Date: October 12, 2021

To: Waterford Conservation Commission
From: Maureen FitzGerald, Environmental Planner

Re: **Inland Wetland Application # 21-12: 384, 394 Willetts Avenue
ClubHouse & Roadway Extension
Application Review Comments**

**Proposed Clubhouse
& Recreation Area**

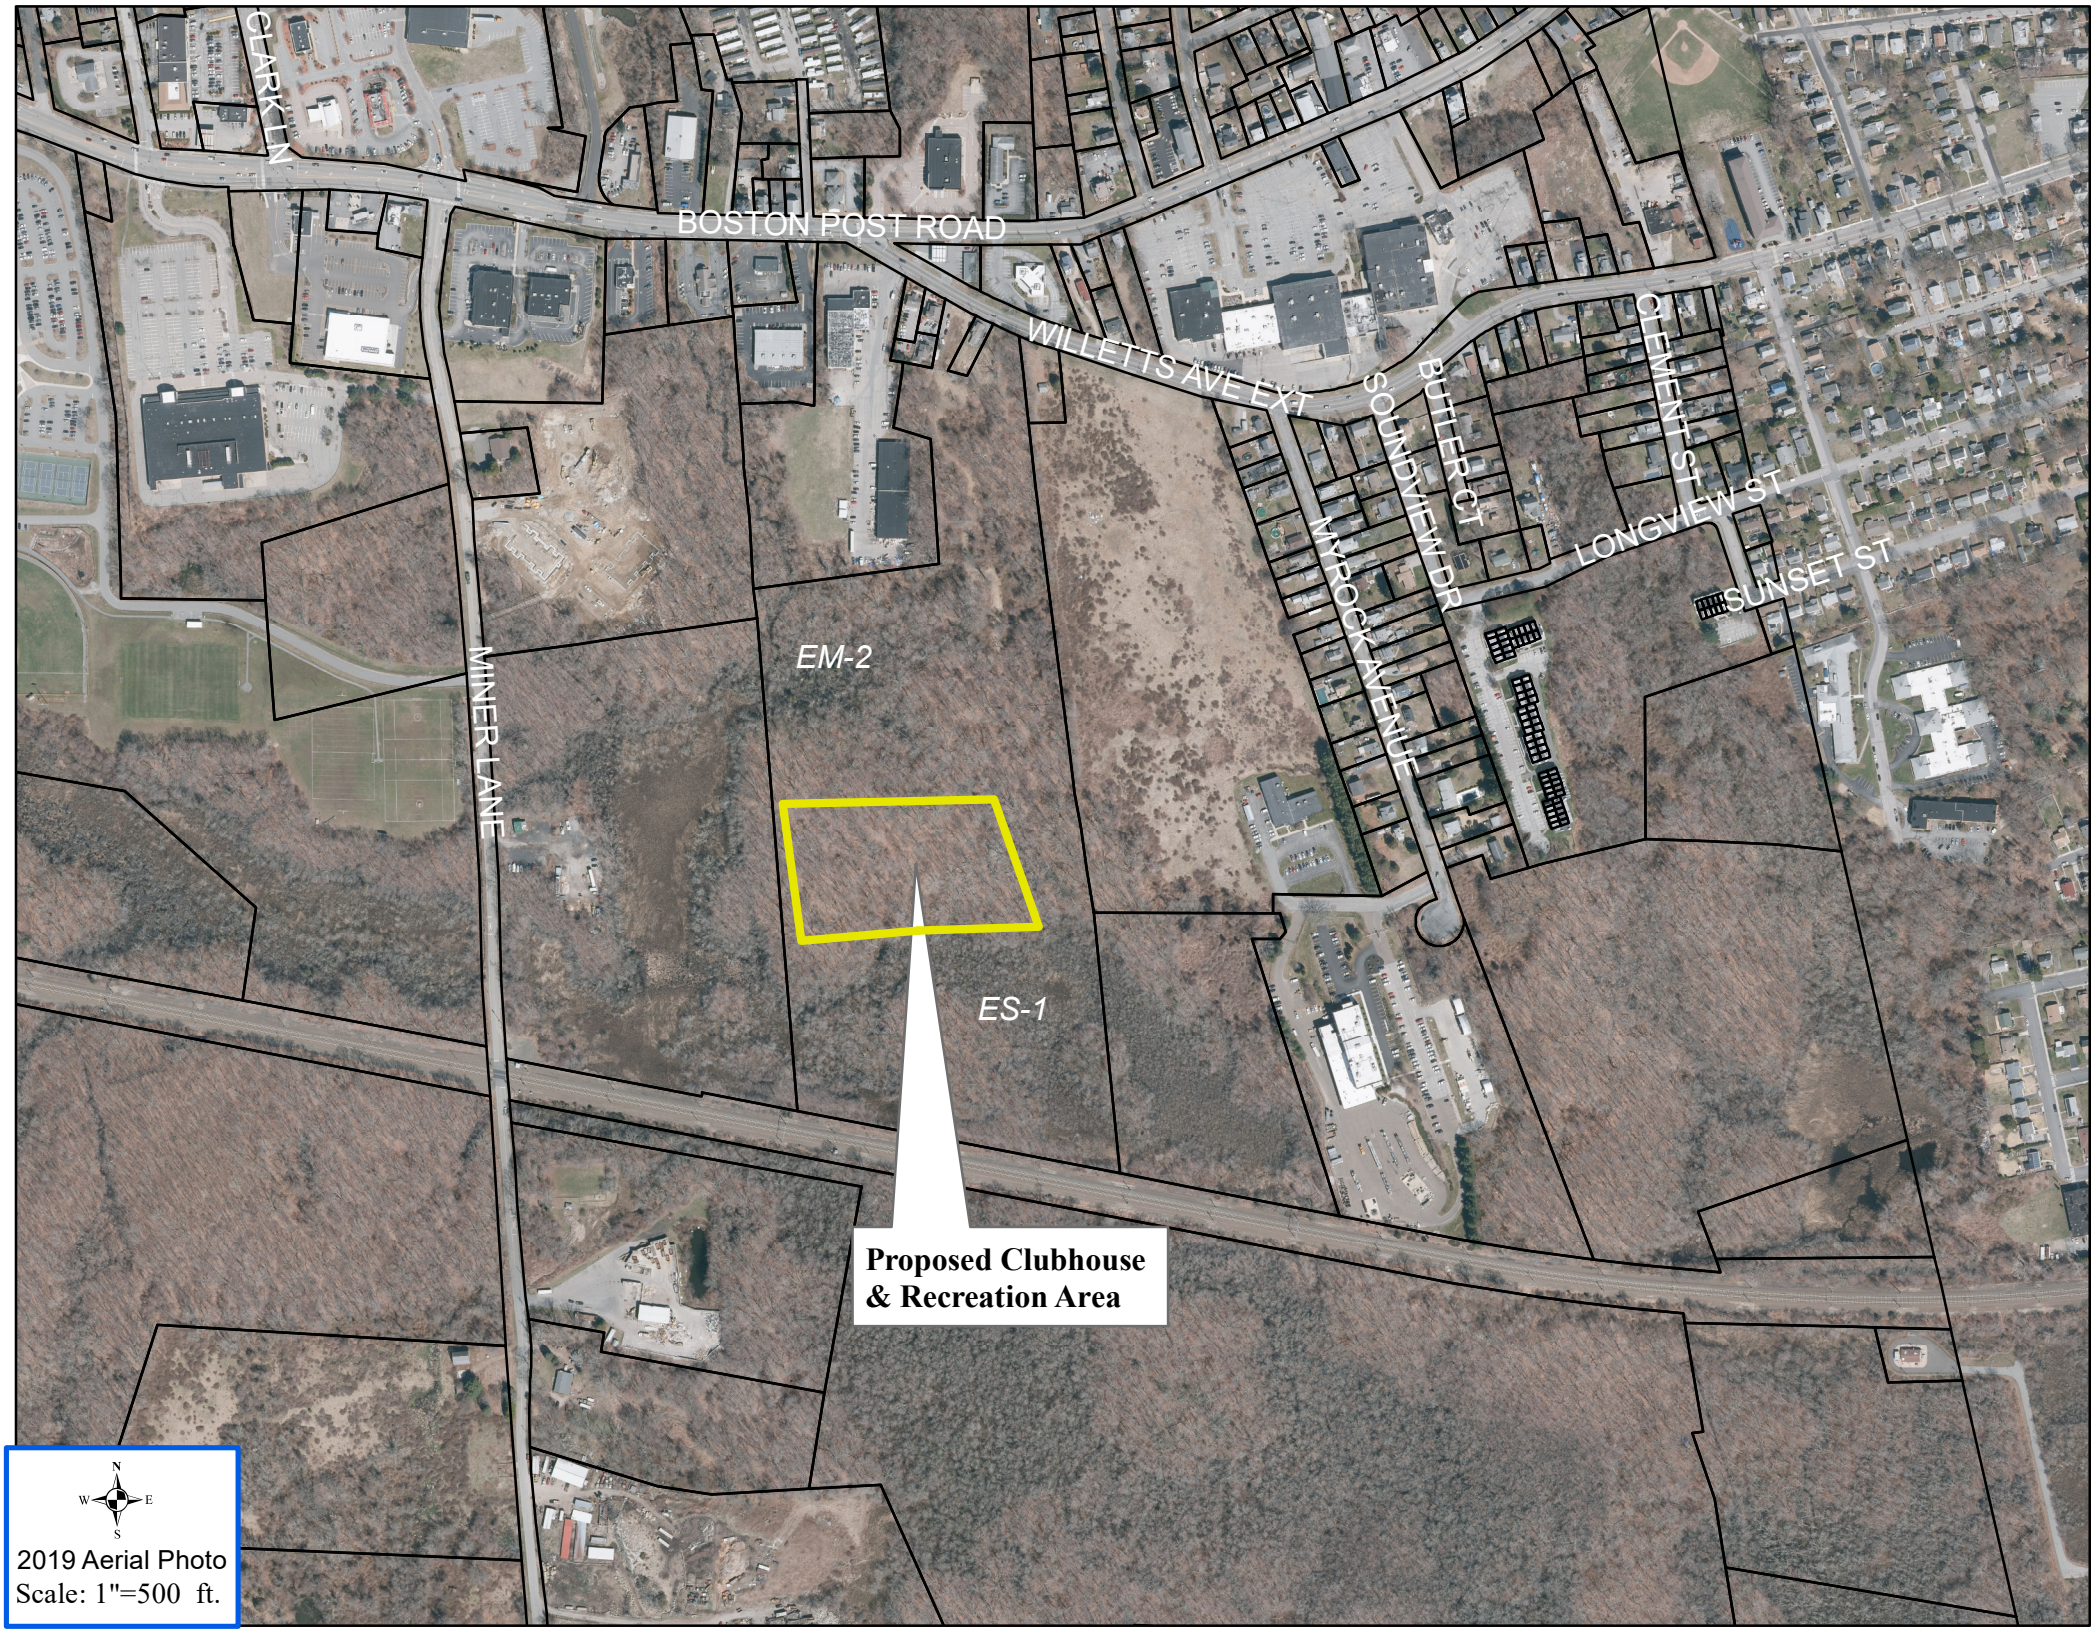
Forested wetland area occurs to the north and to the south of the proposed activity. The wetlands are associated with the East Brook tributary to Jordan Brook and are identified as EM-2 north of the cul-de-sac and ES-1 south of the clubhouse and recreation area. EM-2 wetland is ranked as a comparatively low value wetland in the watershed and the ES-1 wetland is ranked as an average value wetland in the watershed. Wetland functions and values have been affected by the surrounding urbanized environment of Route 1. The wetlands are important resources in the watershed and support varied habitat types, a perennial stream (East Brook) and a potential vernal pool resource in EM-2 according to the wetland assessment report submitted for the apartment development.
